Hotline Fix – ZM55-006

A/C Output temperature rises after brake application

ZM Outlander Petrol with PR25 engine MY22-MY24

(Ref. Location of part number on ECU label)

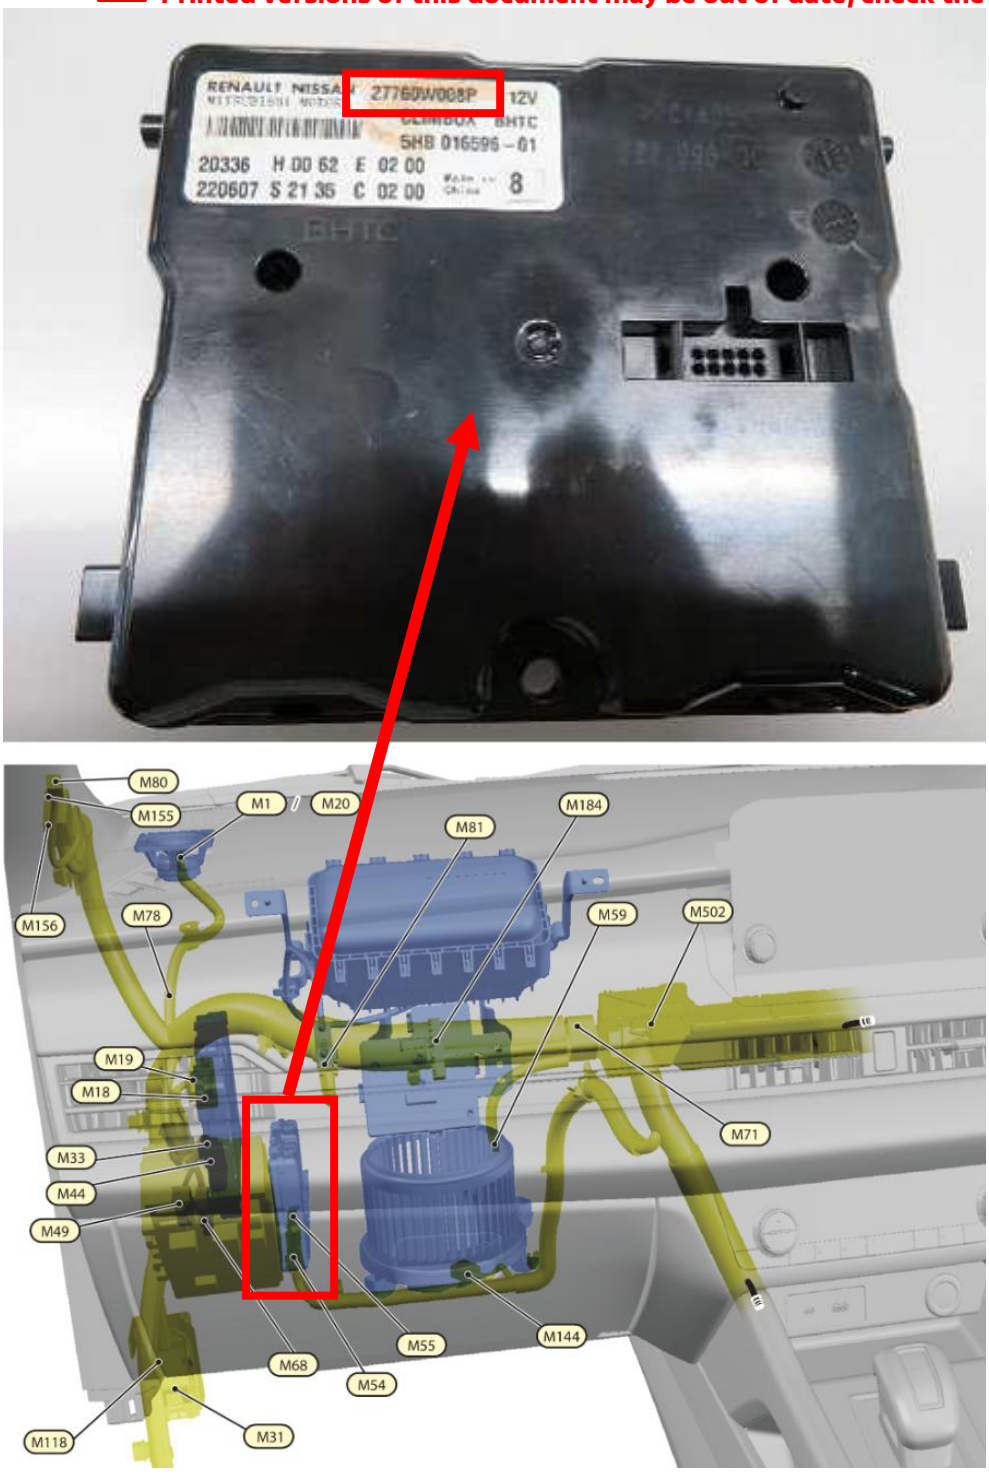
Model	Part Name	AMPLIFIER Part No.		Quantity	A/C system	Remarks
		<New>	<Old>			
Outlander	AMPLIFIER, HVAC	27760W024P	27760W000P ※1 27760W006P ※2	1	DUAL A/C Without seat heater	Check the part number on the label of the ECU installed in the vehicle and replace it with the corresponding <NEW> part number.
		27760W025P	27760W001P ※3 27760W007P ※4	1	DUAL A/C With seat heater	
		27760W026P	27760W002P ※5 27760W008P ※6	1	TRIPLE A/C

※1:(ECU P/N: 27760W000P/27531W003P/27531W007P)
※2:(ECU P/N: 27760W006P/27531W003P/27531W007P)
※3:(ECU P/N: 27760W001P/27531W003P/27531W007P)
※4:(ECU P/N: 27760W007P/27531W003P/27531W007P)
※5:(ECU P/N: 27760W002P/27531W004P/27531W008P)
※6:(ECU P/N: 27760W008P/27531W004P/27531W008P)
